**VILLAGE OF DOWNERS GROVE**  
**Report for the Village Council Meeting**  
**8/18/2015**

<b>SUBJECT:</b>	<b>SUBMITTED BY:</b>
Special Use, Planned Unit Development and Rezoning for an apartment building at 5100 Forest	Stan Popovich, AICP Planning Manager

<b>SUBJECT:</b>	<b>TYPE:</b>	<b>SUBMITTED BY:</b>
15-PLC-0019 5100 Forest Avenue	Planned Unit Development and Special Use	Patrick Ainsworth, AICP Planner

#### **PUBLIC SAFETY REQUIREMENTS**

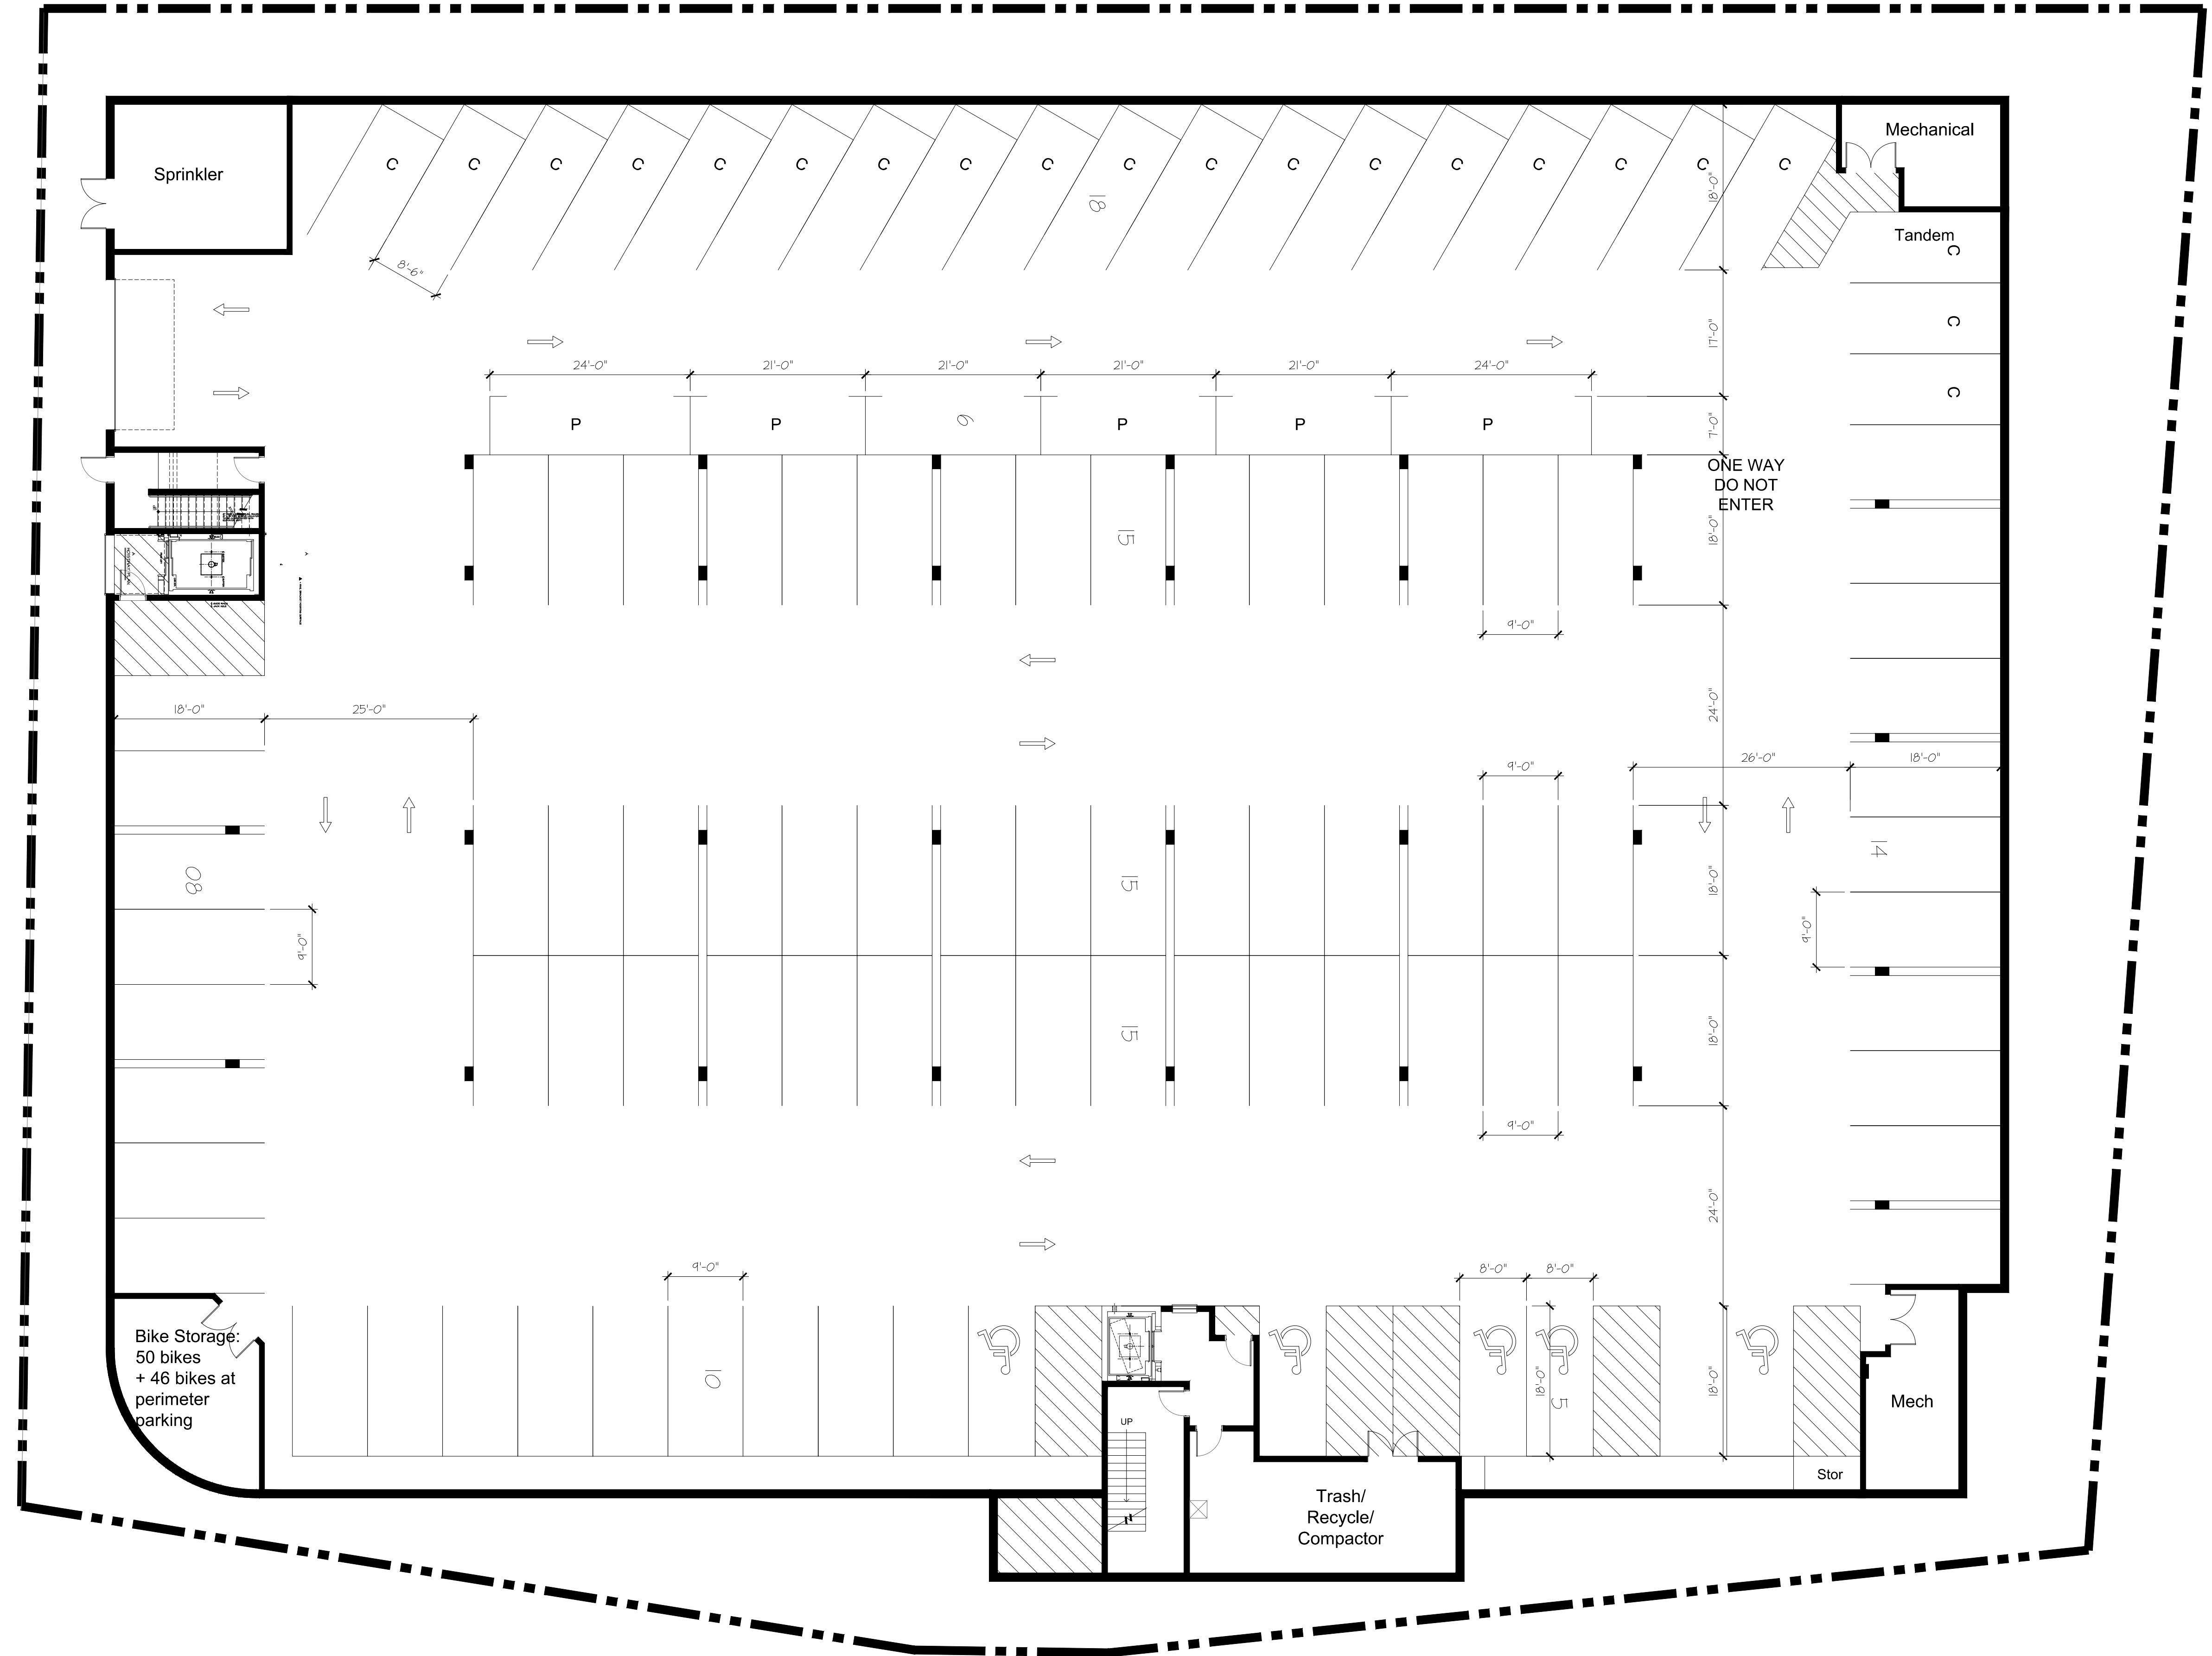
Concern	Response
Inadequate parking for visitors, overnight guests and building support vehicles.	<ul style="list-style-type: none"> <li>• Petitioner submitted a revised basement parking level that provides four additional spaces, bringing the number of parking spaces up to 106</li> <li>• Commuter parking lots are open to the general public after 11:00 am on weekdays and all day on weekends and holidays</li> <li>• Overnight parking is currently available in Commuter Lot L and the Parking Deck</li> </ul>
Use of Lot D for overflow parking	<ul style="list-style-type: none"> <li>• Through contractual obligations with Metra, the Village must maintain these parking spaces for commuters</li> <li>• The lot is available to the general public after 11:00 am on weekdays and all day on weekends and holidays</li> <li>• The Village Council has the discretion to permit overnight parking in this lot</li> </ul>

The petitioner has revised their interior parking plan to provide an additional four parking spaces, bringing their total to 106 interior parking spaces for a 1.19 parking space to unit ratio. This ratio is similar to the Institute of Traffic Engineers estimated peak demand of 107 parking spaces for 89 apartment units. This ratio is also within the range of provided parking in other Chicagoland multi-family developments.
